OVERALL SITE PLAN  
SCALE: 1"=80'

**RECORD DRAWING**  
RECORD DRAWING INFORMATION IS PROVIDED BY PEASE & SONS, INC ON 05-04-2022. RECORD DRAWING INFORMATION WAS REVIEWED BY R. HAND OF SITTS & HILL ENGINEERS AND THE INSTALLATION SUBSTANTIALLY CONFORMS TO THE APPROVED PLANS. RECORD DRAWING CHANGES ARE ON THE CAD FILES SUBMITTED WITH THIS DOCUMENT.

**BCRA**  
PROJECT: FOR PUYALLUP SCHOOL DISTRICT  
**KESSLER CENTER**  
1501 39TH AVENUE SOUTHWEST  
PUYALLUP, WA 98373

**C2.6**

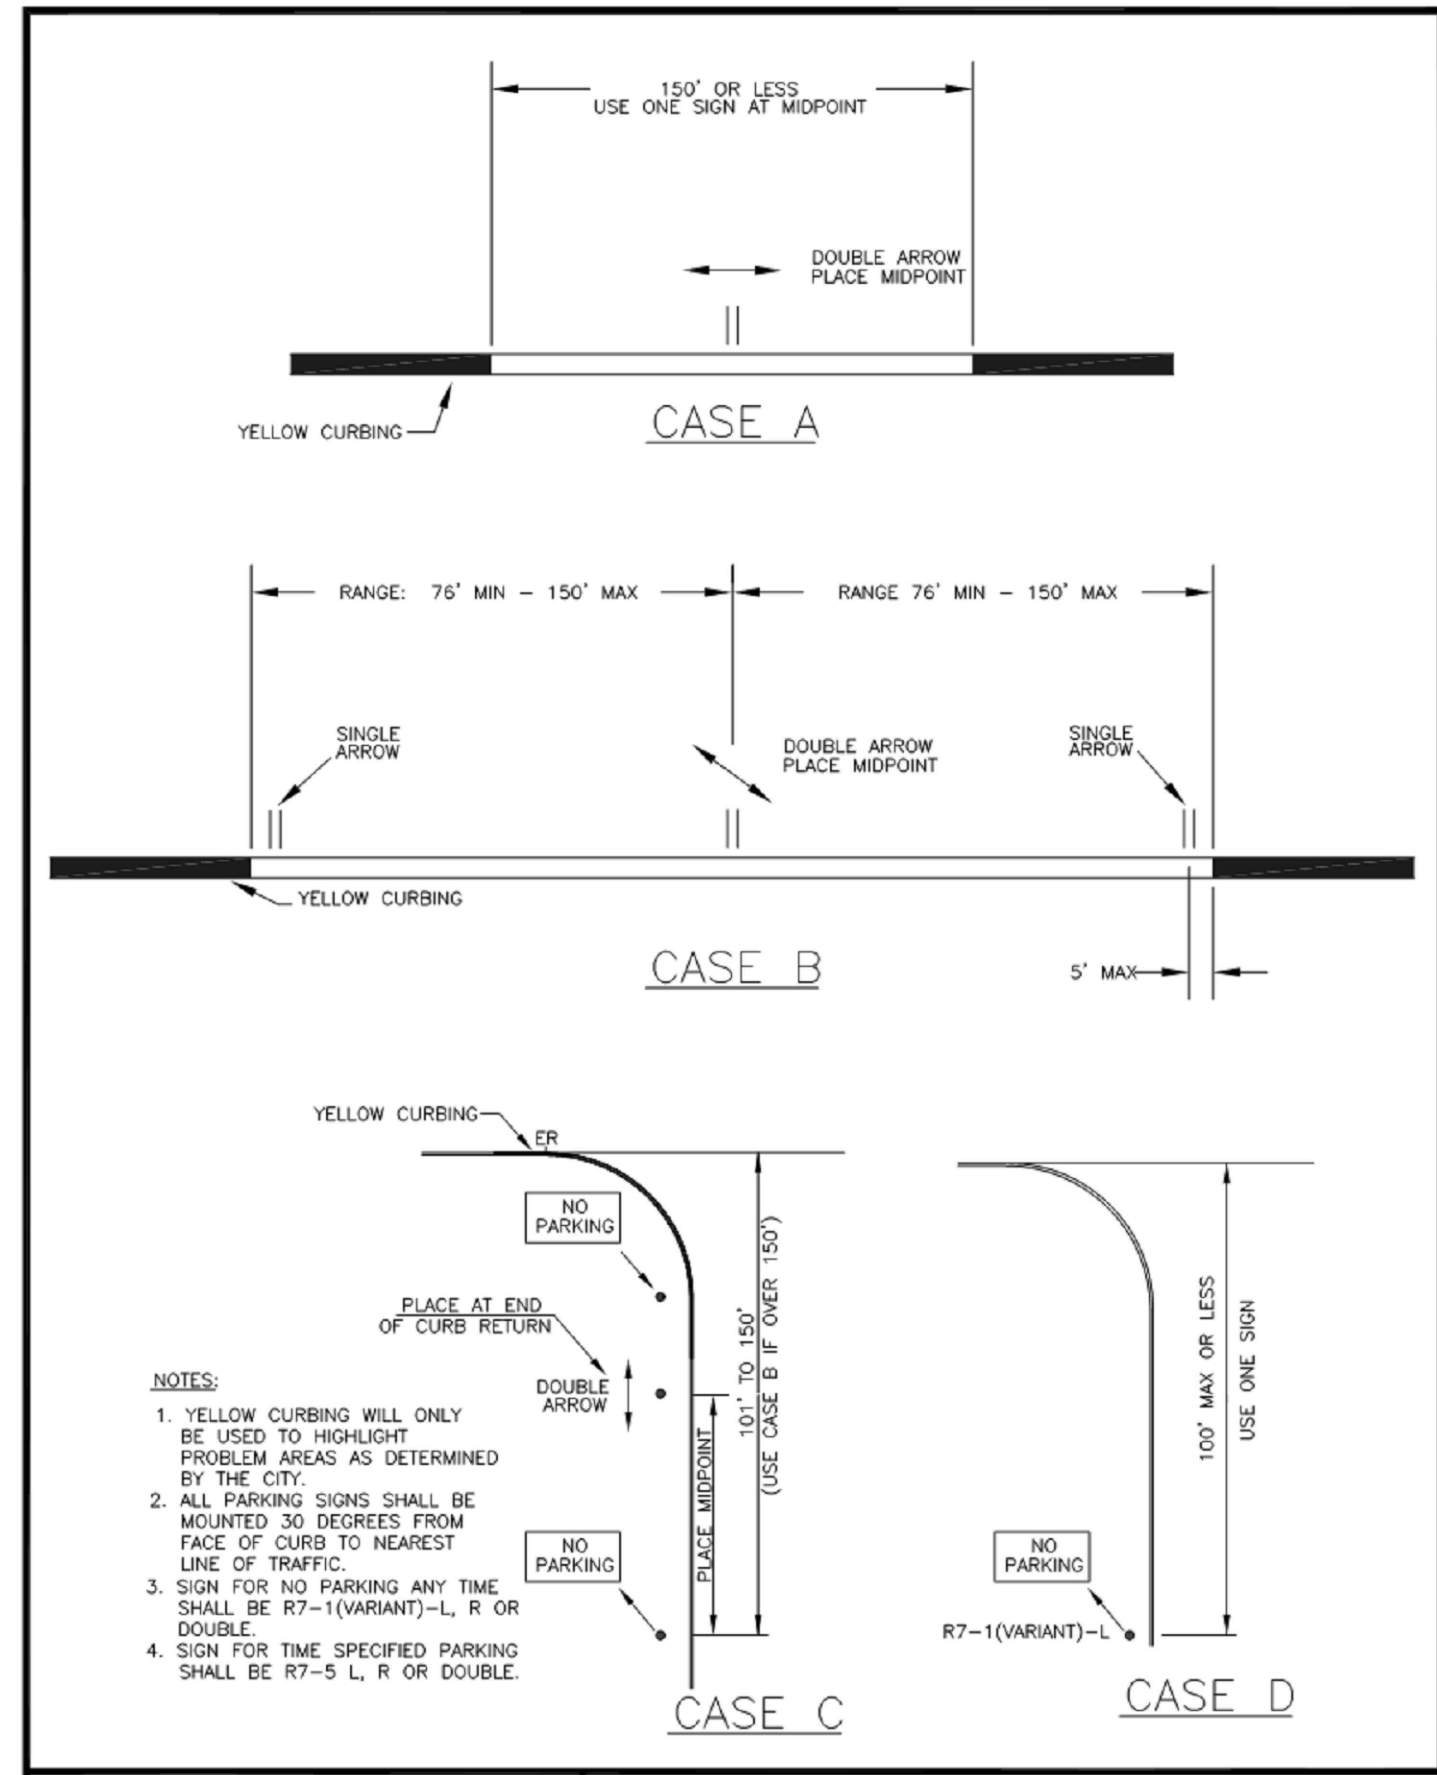
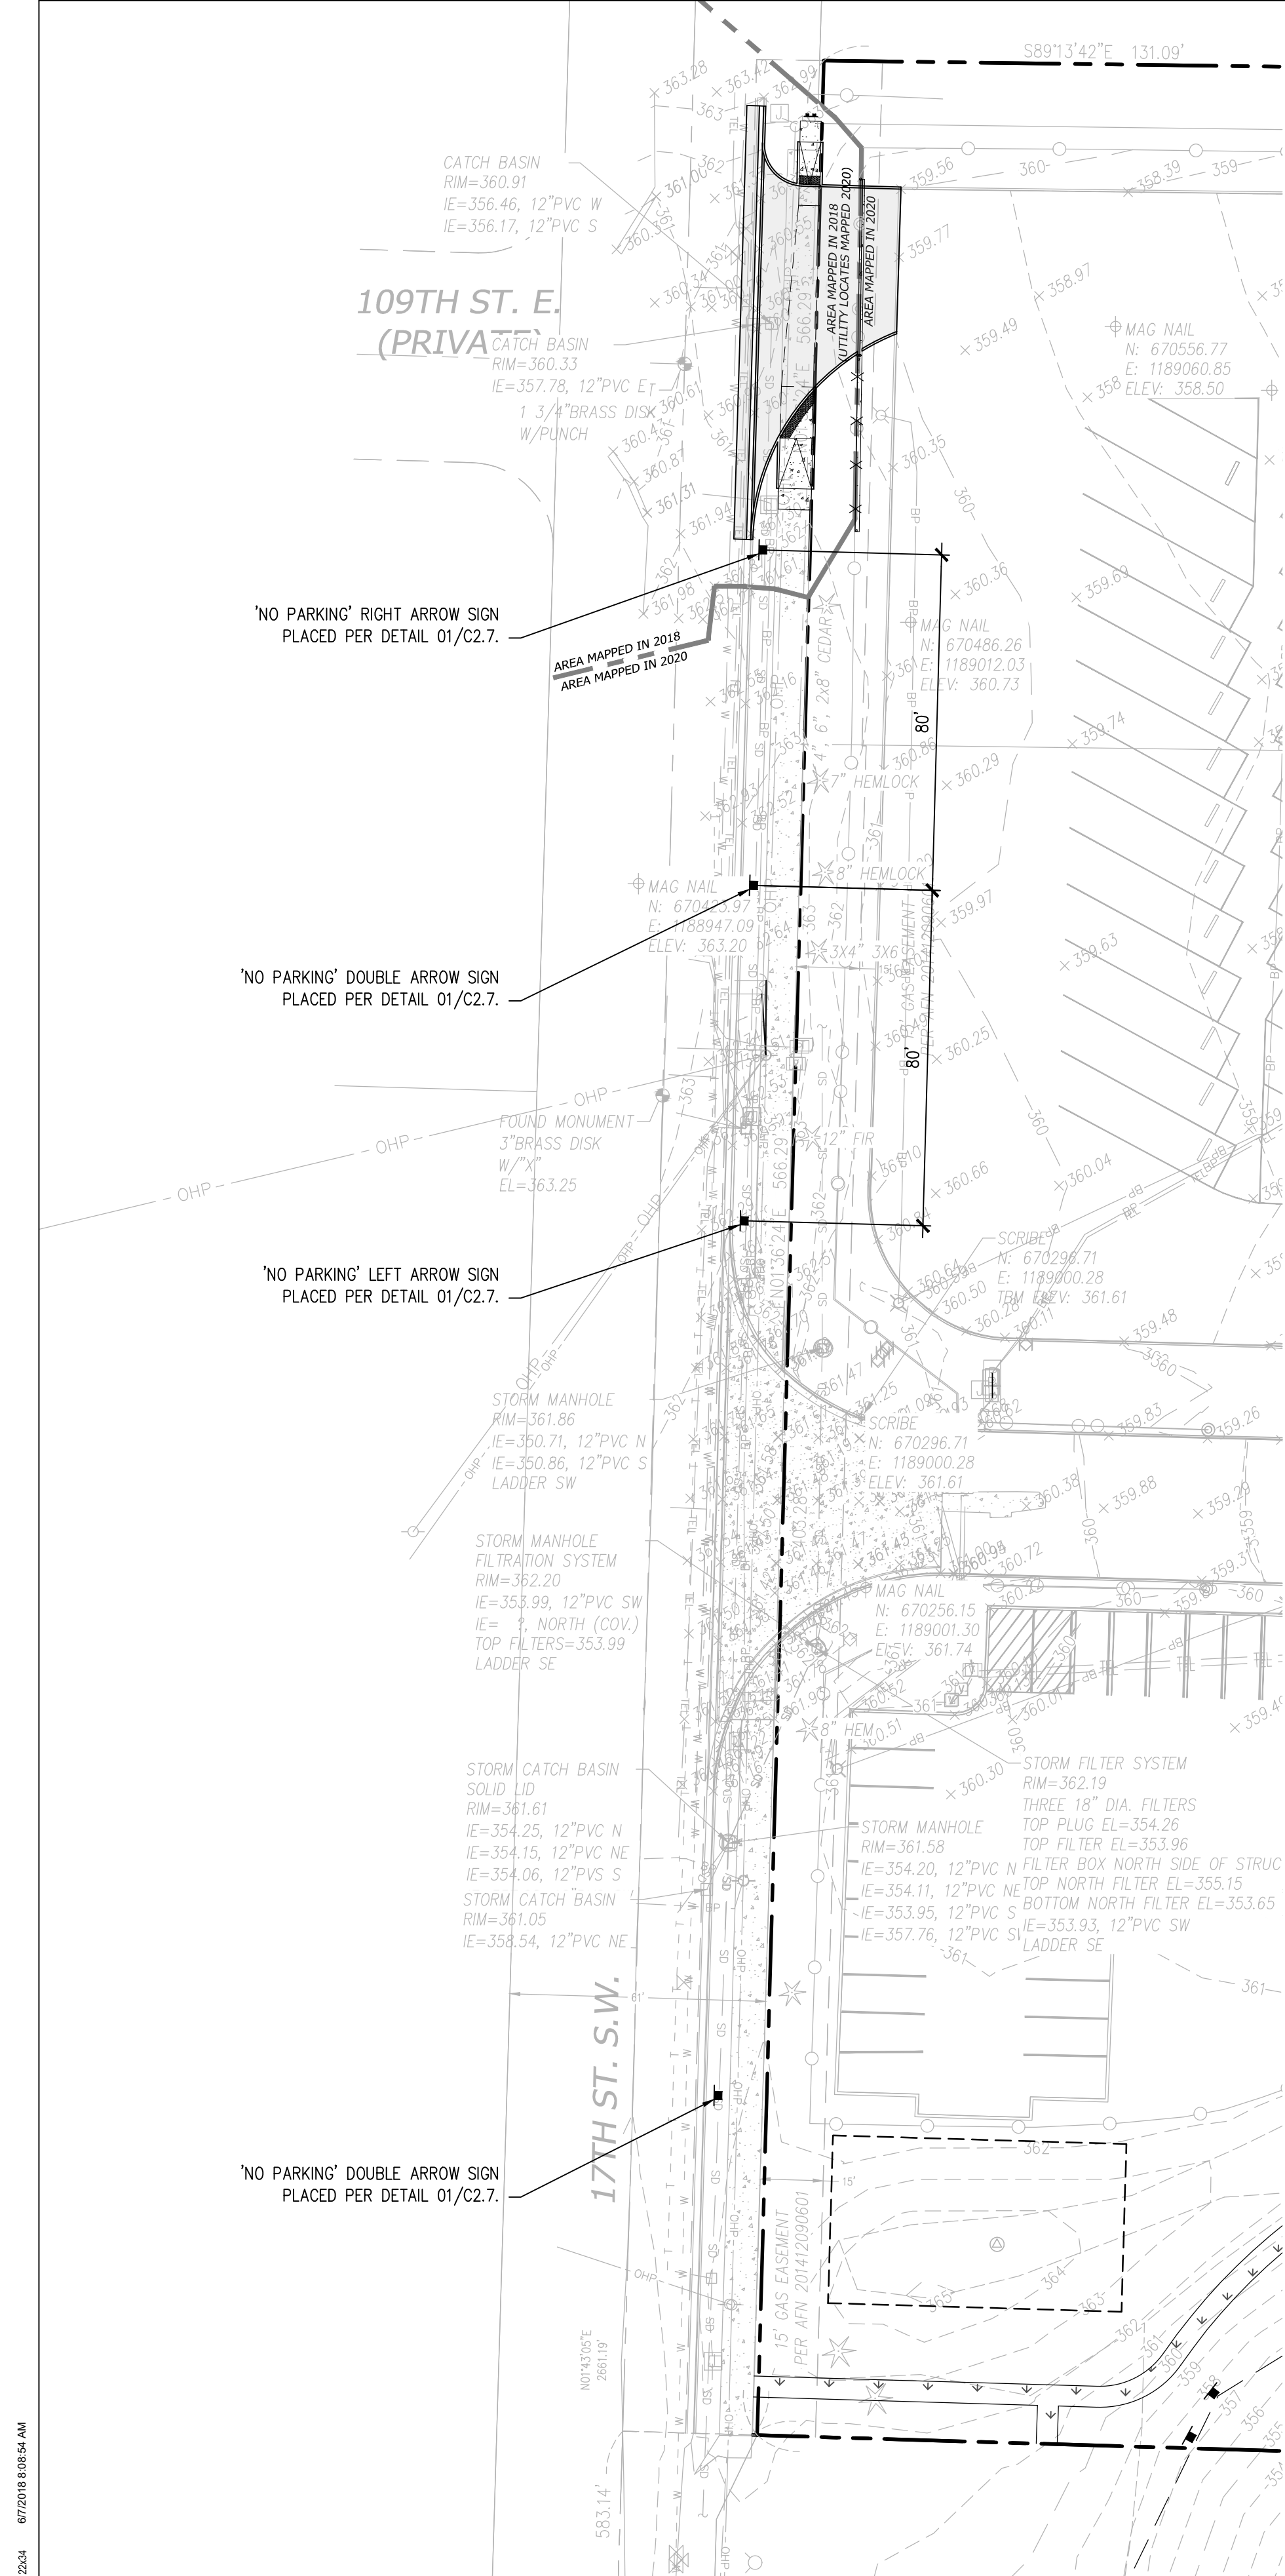
**SHEET C2.6 - SURFACING DETAILS**  
 1. REVISE Detail 04 - Enlargement Detail to graphically reflect the change described on Sheet C2.1 as shown on the revised sheet C2.6. ADDED depressed concrete curb callout to the detail.

**SHEET C2.6 - SURFACING DETAILS**  
 2. ADD Detail 09 - Depressed Concrete Curb detail as shown on the revised sheet C2.6.

**05 TYPICAL UTILITY STRUCTURE EXCAVATION, BEDDING AND BACKFILL DETAIL**  
SCALE: N.T.S.

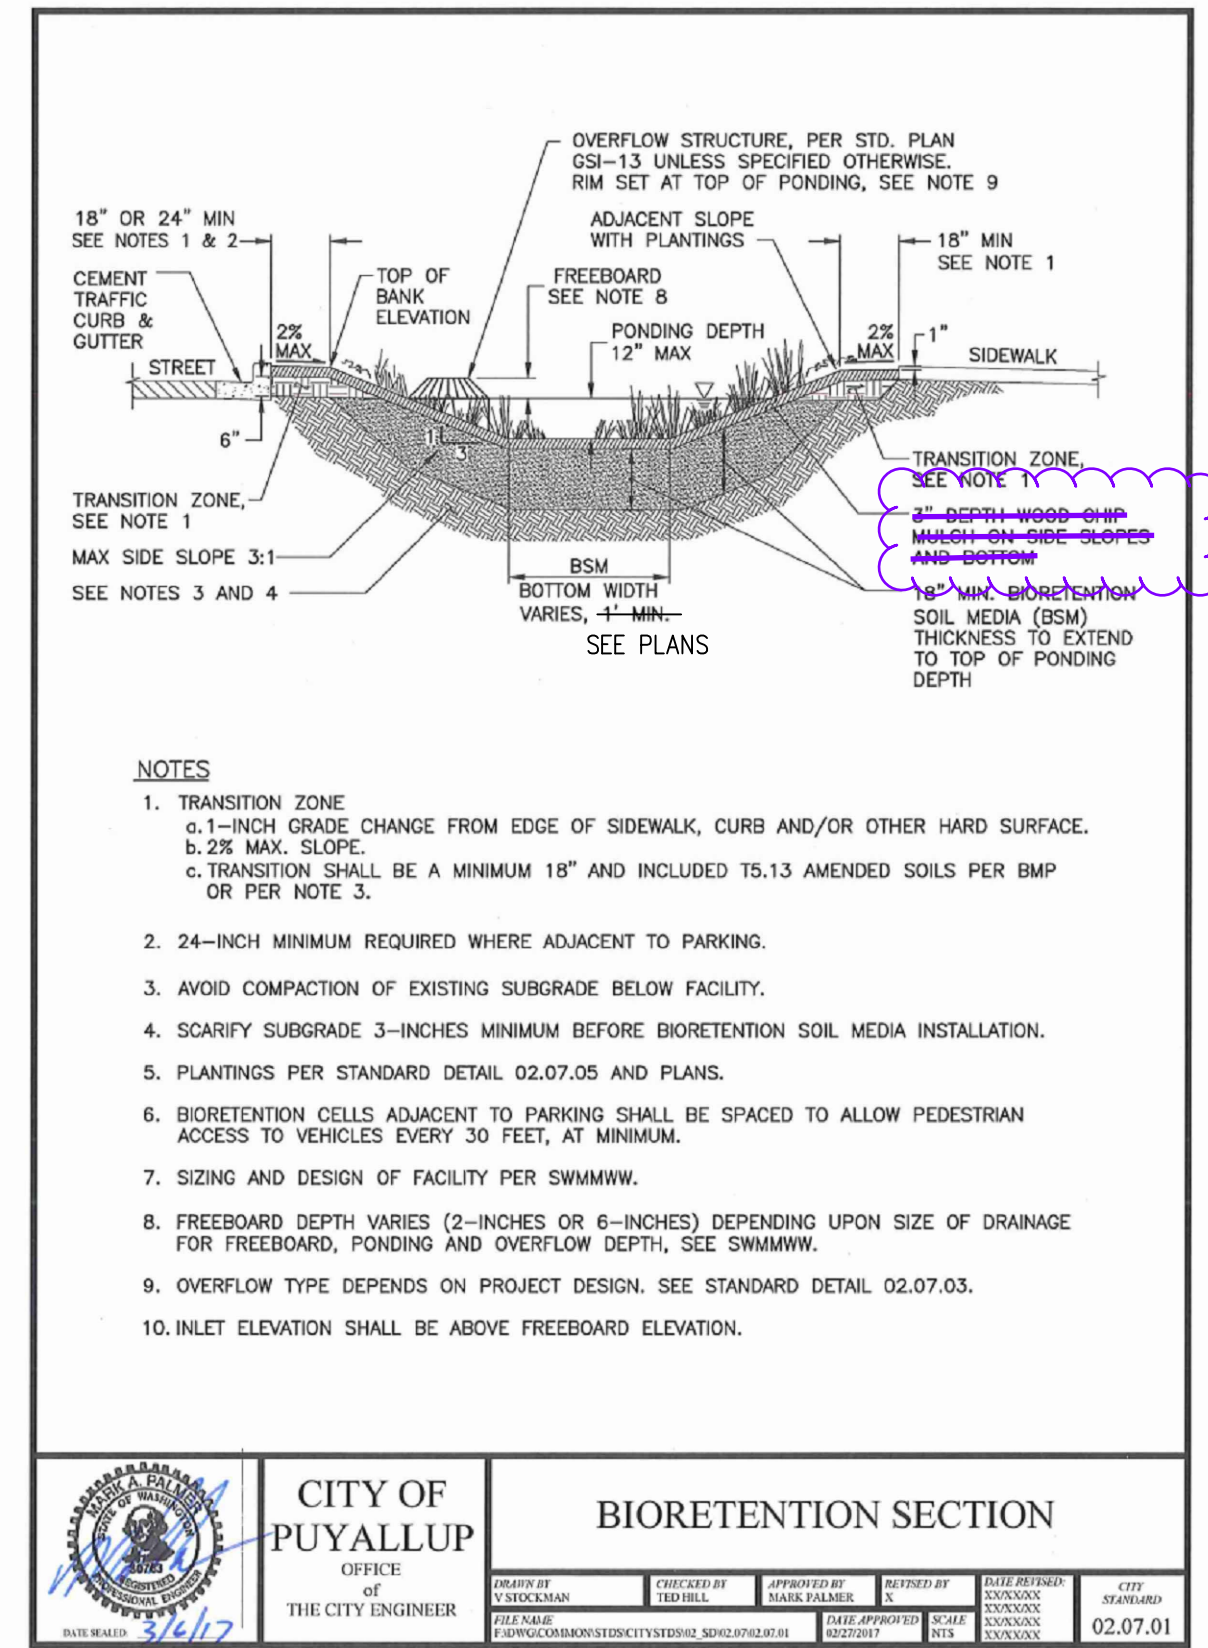
RD  
REVISE BACKFILL REQUIREMENTS

**06 BIORETENTION SECTION**  
SCALE: N.T.S.

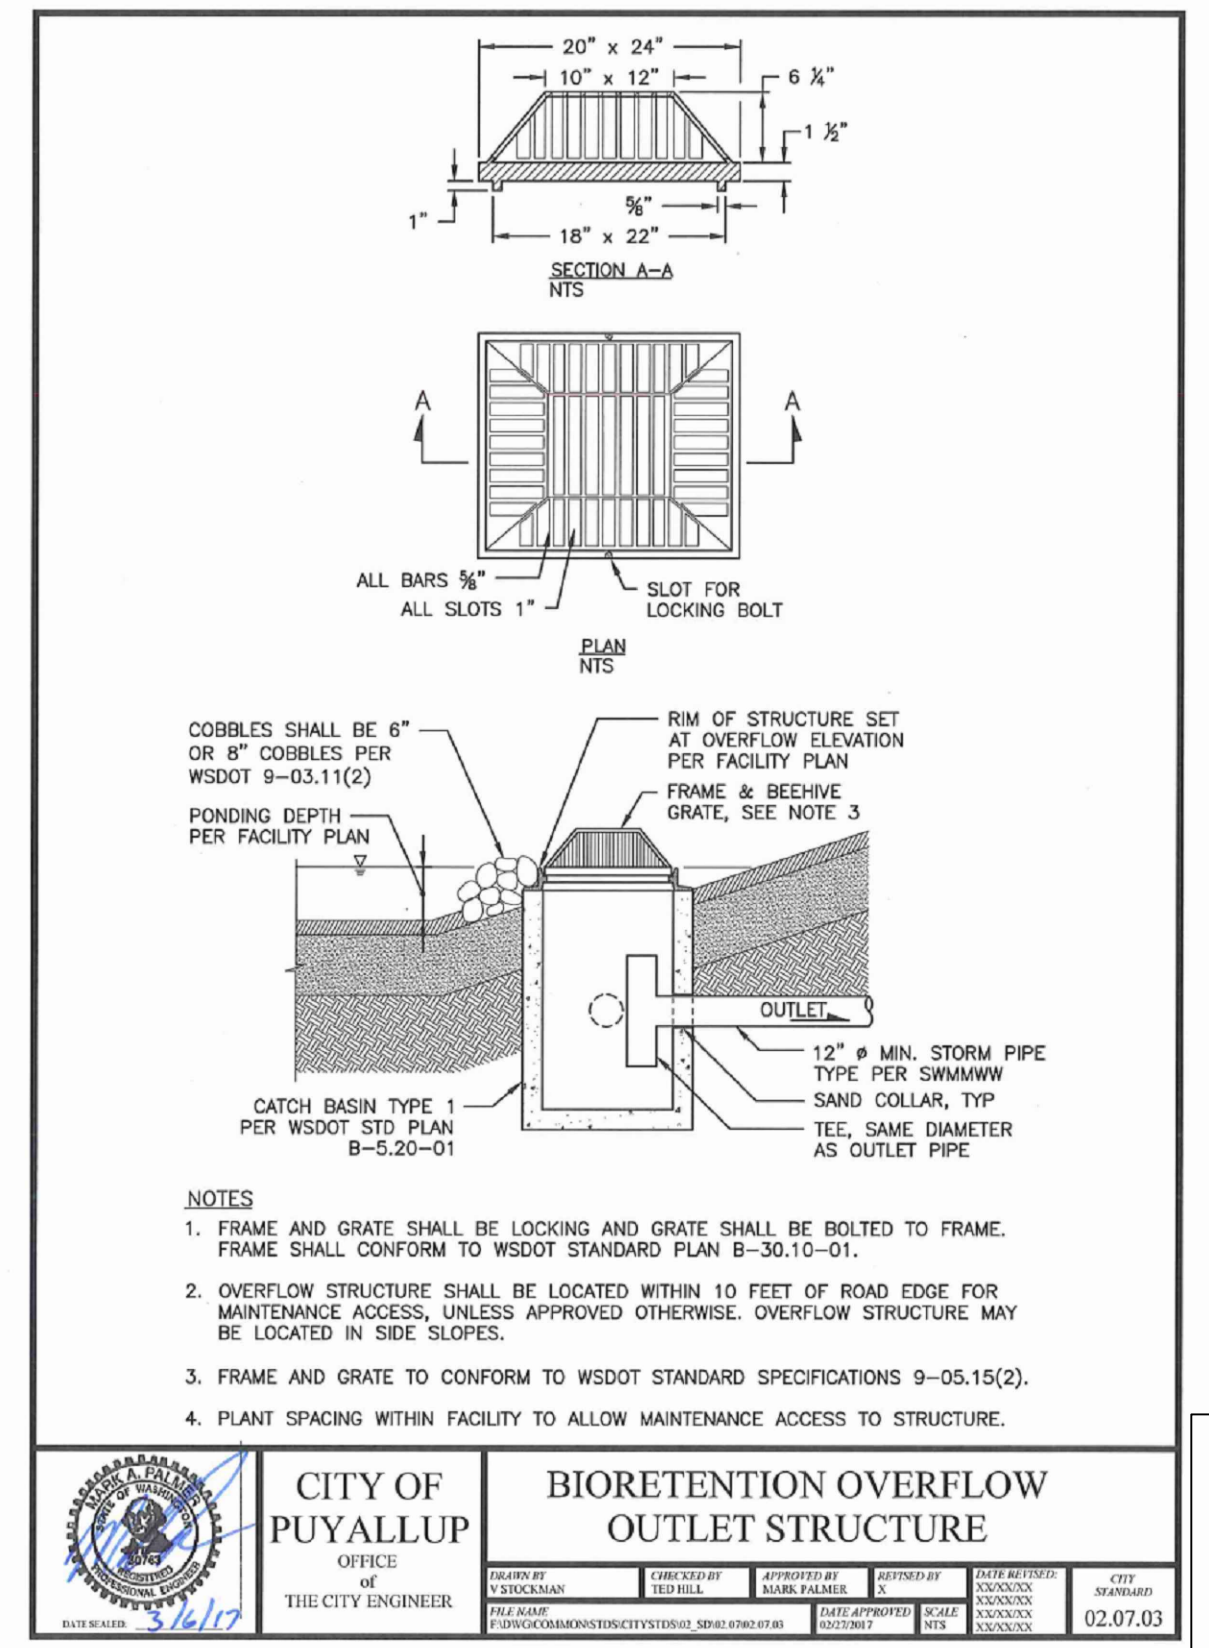
RD  
NOT INSTALLED PER LANDSCAPE ARCHITECT DIRECTION
